TECHNICAL BULLETIN ULTRAA-K®

SUBJECT: SURELOK® Actuator
Mounting Hardware Update

LIT NO: T89004
DATE: August 2016

REVISION: A

View from rear of slider/trailer

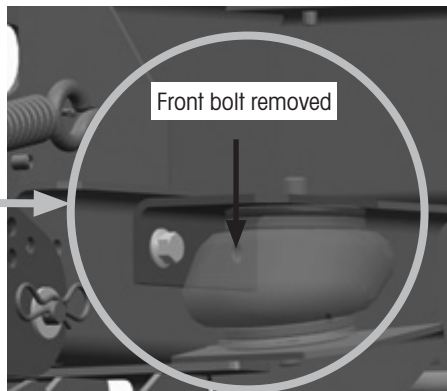
For trailers built between 01/01/2014 and 07/01/2015 and equipped with ULTRAA-K® and SURELOK®, the forward (front) mounting bolt of the SURELOK actuator upper mounting bracket must be removed and the SURELOK actuator should be inspected.

In some cases the SURELOK actuator may contact this bolt, which is to be removed. If the SURELOK actuator is worn through, lacerated or damaged, replace the actuator.

Remove forward (front) mounting bolt
(bolt hole left vacant)

Actuator inspection

NOTE: When any ULTRAA-K slider suspension system equipped with SURELOK ships from Hendrickson, the front mounting bolt hole is left vacant while the rear mounting bolt is installed by Hendrickson. The front mounting bolt hole should remain vacant; Hendrickson does not recommend adding a bolt to this location. Refer to the diagrams below:

In July 2015, Hendrickson Trailer Commercial Vehicle Systems announced a change to the SURELOK actuator bracket on ULTRAA-K slider suspension systems that specify SURELOK. The SURELOK actuator upper mounting bracket is well supported against the inner side rail upper flange. Previously, the bracket featured both front and rear mounting bolts. As of July 2015, the actuator bracket is fastened with the rear mounting bolt only.
